**Application for Permission Under Section 16 of the Town Planning Ordinance (Cap. 131) for Proposed Temporary Educational Institution (Teaching Farm) and Associated Excavation of Land for a Period of Three Years at Various Lots in D.D. 16, Wo Tong Pui, Tai Po, New Territories
(Planning Application No. A/NE-LT/794)**

Submission of Further Information

Planning Application No. A/NE-LT/794

Responses to Comments – Departmental Comments (September 2026)

Figure 2.3 Proposed Plant Locations

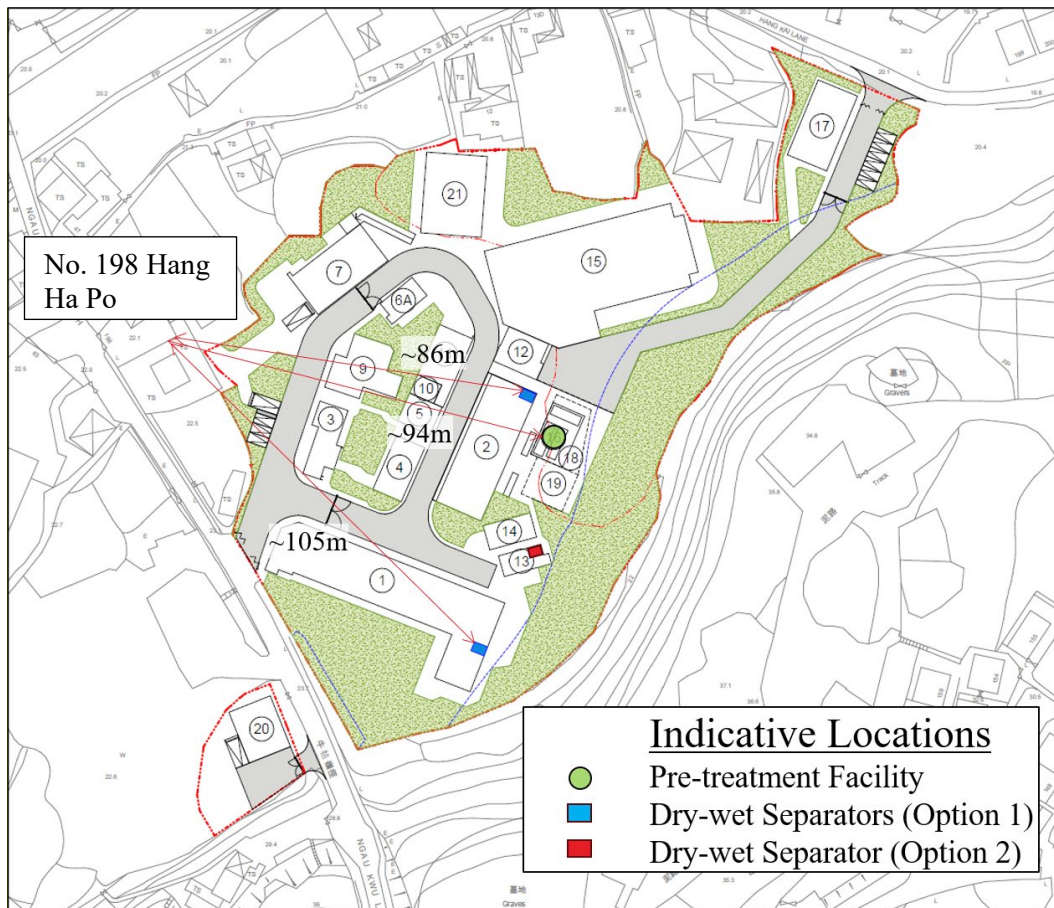
No.	Comments	Responses
2.	Environmental Protection Department, dated 19 August 2026 EPD has the following comments on the submitted Appendix D Environmental Assessment: <u>Noise</u> 1. Table 2.2: Compared to the pre-submission received in May 2026, the remark “The proposed Block 16 will be uncovered structures on ground floor.” has been added for the Pre-Treatment Facilities in Table 2.2. Please clarify the design and address whether there is any potential fixed noise impact on the nearby Noise Sensitive Receivers (NSR) from the proposed uncovered Pre-Treatment Facilities. <u>Water Quality</u> 1. Please review the header of Table 4.6. 2. Figure 4.3: Please review the description “Provide 20mins retention to 10% of maximum runoff a 1-2 year rainstorm” as it seems not quite tally with description in paragraph 4.5.7 and also Figure 3-1 of Appendix E Drainage and Sewerage Impact Assessment. Please also clarify if “1-2 year rainstorm” should read as “1-in-2-year rainstorm”. <u>Waste Management Implications</u> 1. Section 5.2.24: please review if the average general refuse generated per day should be 0.28m³. 2. Table 5.7: please review if the estimated waste quantity to be reused on site for inert C&D materials and non-inert C&D materials should be 778m³ and 141m³ respectively; and suggest to revise the title of row 3 as “Estimated Waste Quantity to be reused on-site” .	Noted. Please refer to the responses below and Appendix B for the replacement pages of the updated Environmental Assessment (EA). The potential fixed noise impact arising from the proposed wastewater pre-treatment facility and dry-wet separators have been assessed and the assessment results have been supplemented in Section 2.4. The facilities are low-height structures located at ground level and are screened by intervening buildings and terrain from nearby NSRs. Please be advised that the header of Table 4.6 has been updated as “Wastewater and Sewerage Loading Estimations”. Noted, Figure 4.3 has been updated and aligned with the latest Figure 3-1 of the Drainage and Sewerage Impact Assessment. The description in Paragraph 4.5.8 has been updated in accordance with the proposed stormwater management as illustrated in Figure 4.3. Noted and updated accordingly. The average general refuse generated per day should be 0.28m³. Noted and updated accordingly. The estimated waste quantity to be reused on site for inert C&D materials and non-inert C&D materials should be 778m³ and 141m³ respectively. The title of row 3 is updated accordingly.

2.4.1 As mentioned in **Section 2.2**, wastewater pre-treatment facilities and dry-wet separators, will be provided for manure handling to improve wastewater management. Under the current design as shown in **Figure 2.3**, the wastewater pre-treatment facility is proposed at Block 16, which comprises an uncovered structure located on the ground floor. Either two dry-wet separators will be installed within the existing beef cattle barn (Block 1) and young stock barn (Block 2), or one dry-wet separator will be installed within the existing Block 13. The final arrangement will be determined during the detailed design stage. For

2.4.2 For Option 1, the two proposed dry-wet separators would be located in a semi-enclosed area. Moreover, the wastewater pre-treatment facility will be below 2 m high and located at ground level, which is lower than the existing and proposed nearby structures, including the Young Stock Barn (Block 2), Store (Block 12), Dairy Barn (Block 15) and Accommodation Block (Block 17), which are approximately 3–9 m high. Together with the intervening terrain, these structures are expected to screen the proposed facilities from the nearby village houses. Consequently, there would be no direct line of sight between the proposed facilities and the neighbour village houses.

Figure 3.2 Buffer Distance from Road to Buildings with Air Sensitive Uses

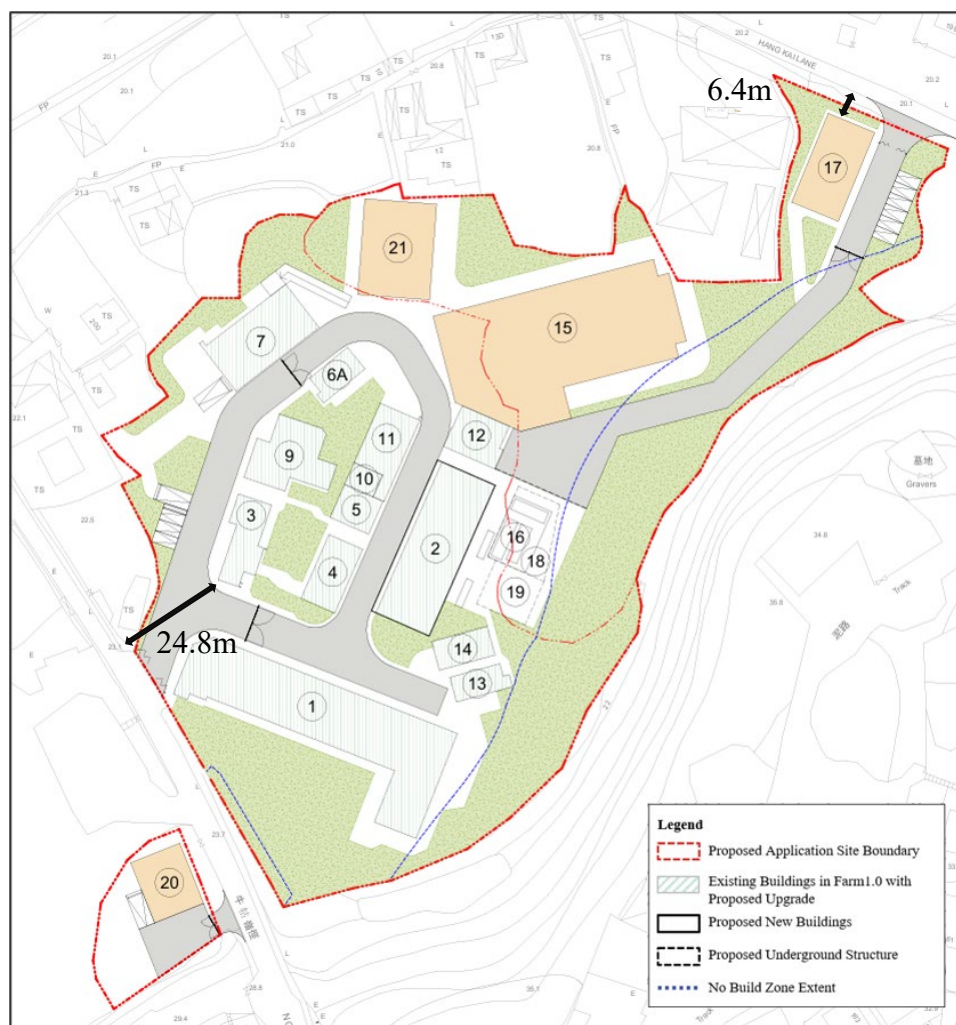
No.	Comments	Responses
3.	Environmental Protection Department, dated 20 August 2026 EPD has the following comments on the submitted Appendix D Environmental Assessment: <u>Air Quality</u> 1. Section 3.1.1: Please confirm whether the Development Bureau Technical Circular (Works) are applicable to this project. According to the RtC, they are expected to be removed, but remains in the list of applicable legislations, standards and guidelines. 2. Table 3.3: - please confirm if CO is measured in Tai Po AQMS in 2025. If not, please indicate with “-”; and - please revise the last sentence of note [3] to read “Number of exceedances allowed per calendar year under the AQOs is shown in ().”. 3. Table 3.4 to 3.5 and Section 3.2.5: Please confirm whether annual FSP for grid 37,49 exceeded AQO and update the text accordingly. 4. Table 3.6 and Figure 3.1: - the last comment was not addressed properly. The ASRs should be drawn at the locations closest to the site, especially for larger structures such as ASR17; and - please measure the distances without rounding to the nearest 10m. 5. Section 3.5.1: - please demonstrate, using a figure, that the required buffer distance is met for all buildings with air sensitive uses; and	Noted. Please refer to the responses below and Appendix B for the replacement pages of the updated EA. Noted, the Development Bureau Technical Circular (Works) have been removed from the list. Noted, it has been updated accordingly with “-” indicated. Noted, it has been updated accordingly. Noted, please be advised that the annual FSP for grid 37,49 does not exceed AQO and the text has been updated accordingly. Noted, Table 3.6 and Figure 3.1 have been updated accordingly. Noted, the distances in Table 3.6 have been updated accordingly without rounding to the nearest 10m. Noted, Figure 3.2 has been supplemented to demonstrate the buffer distance from road to buildings with air sensitive uses.

No.	Comments	Responses
	- please justify the 5m setback is adequate (e.g., with Transport Department’s confirmation that the road class is local distributor or below). 6. Section 3.5.14 & RtC #11 (Page 14 of the RtC Table): Please clarify where “Attachment A” is provided. 7. Section 3.5 & RtC #12 (Pages 14-15 of the RtC Table): Please provide further information, such as the reliability of the proposed system, to justify that odour will be better managed.	Noted, please be advised that the following road classification have been confirmed by Transport Department (TD): • Hang Kai Lane (Local Distributor or below) • Ngau Kwu Leng Path (Local Distributor or below). Please refer to Appendix C for the confirmation email from TD on road type classification. Please be advised that “Attachment A”- “Micro-Nano Deodorization Technology Description” of the Responses-to-Comments (RtC) during the pre-submission stage does not form part of the Environmental Assessment Report and is attached for reference only to justify the proposed removal efficiency. Please refer to Appendix D for the “Micro-Nano Deodorization Technology Description” for reference. Please refer to Appendix D for the “Micro-Nano Deodorization Technology Description” for further information on the proposed system for odour control.

receivers (buildings). Accordingly, the buffer distances for roads/highways and industrial areas/chimneys recommended in the HKPSG, as listed in **Table 3.2**, are satisfied.
